**Addendum Number 2**

April 8, 2020

Project:  
Proposed Fire Station  
Village of Park Ridge  
Stevens Point, Wisconsin

ELECTRICAL ONE-LINE DIAGRAM

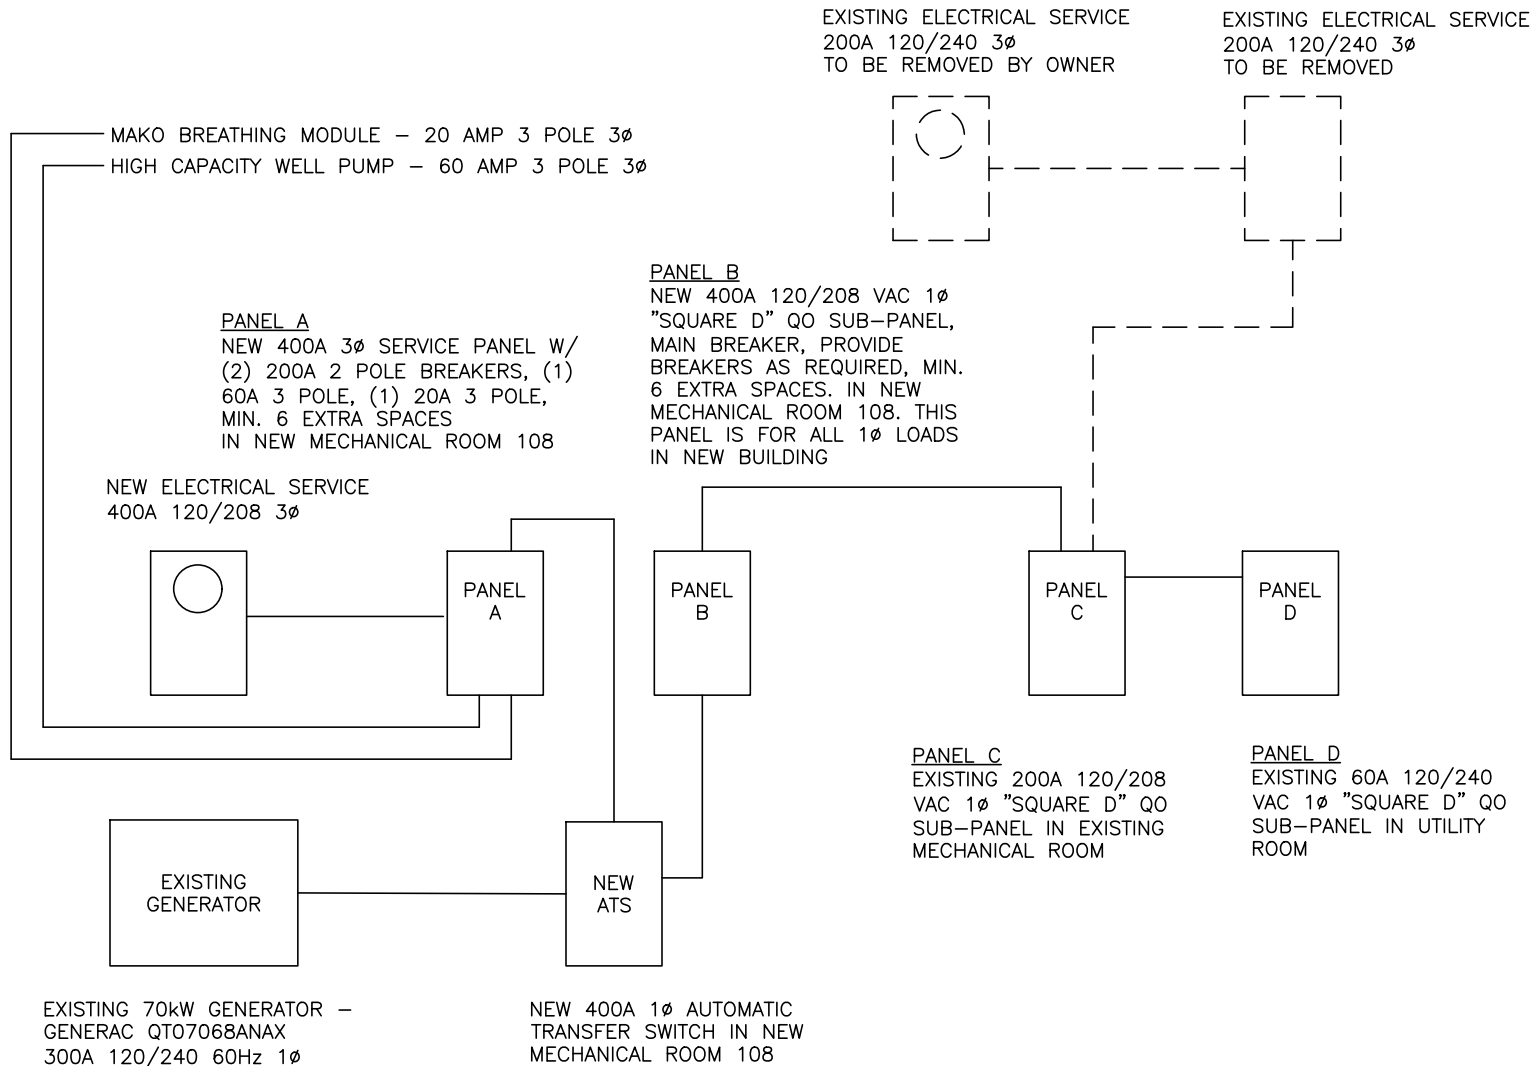
- 14) Metal building panels shall have a Kynar Coating or equal.
- 15) See page 3 for Electrical One-line diagram.
